**Standard Number:** ULC S602

**Standard Name:** Aboveground Steel Tanks for Fuel Oil and Lubricating Oil

**Standard Edition and Issue Date:** 5<sup>th</sup> Edition Dated November 1, 2003 and 6<sup>th</sup> Edition Dated October 1, 2014

**Date of Revision:** June 6, 2005, September 30, 2007, October 1, 2014 and December 1, 2015

Figure 10

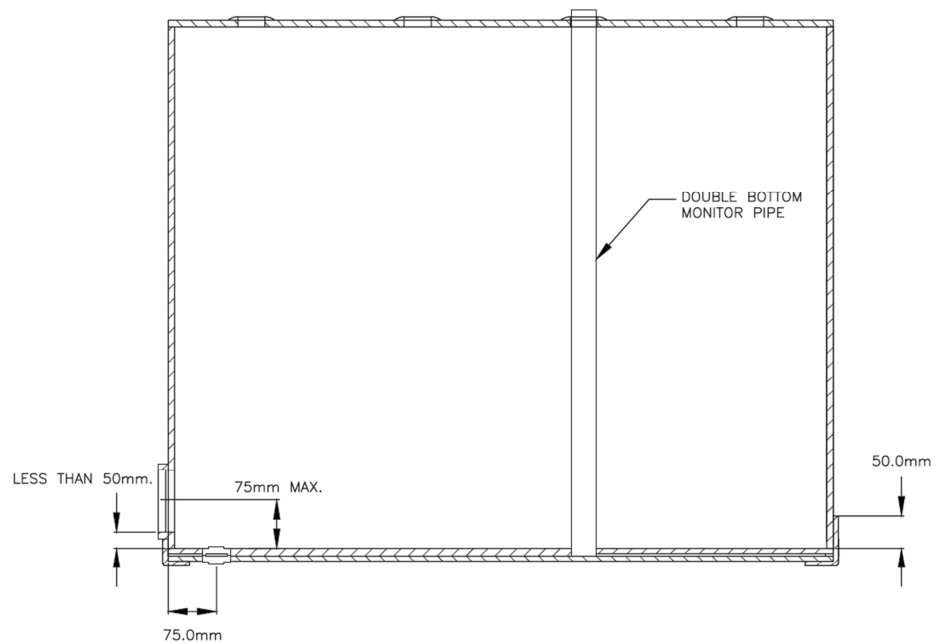
6.1	Info	<b>CONSTRUCTION</b>
6.1.2		Revised 6.1.2 now requires bottom coverage up to 50 mm head height for only obround & cylindrical tanks.
6.1.4		New 6.1.4 now requires a minimum 27 mm ID interstitial vent, which may be combined with 6.1.3.
7	Info	<b>PERFORMANCE</b>

Figure 11

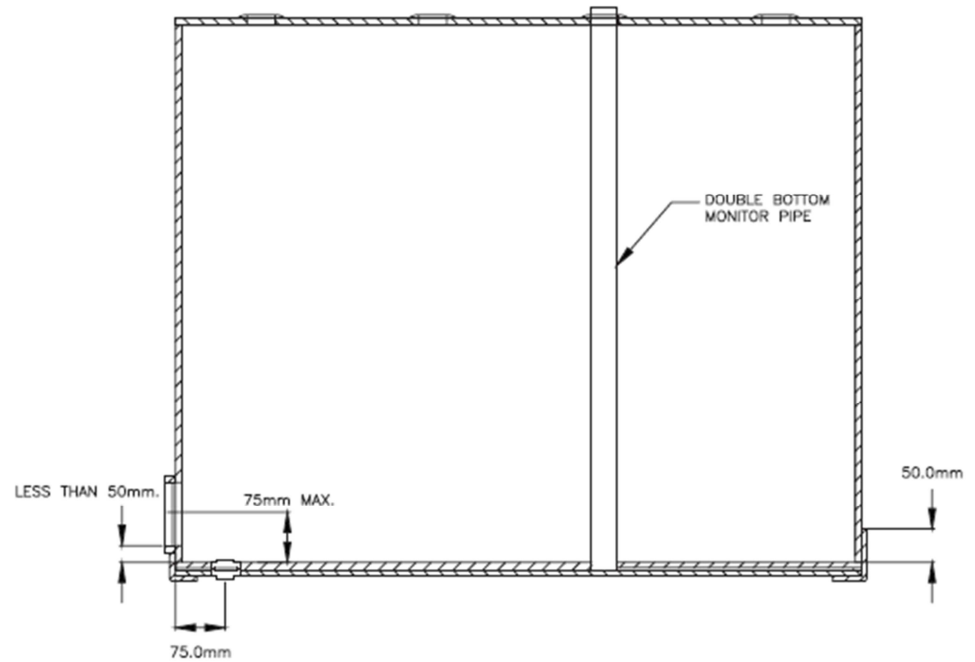
BOTTOM OF THE OPENING SHALL BE WITHIN THE AREA OF THE DOUBLE BOTTOM OR SECONDARY CONTAINMENT
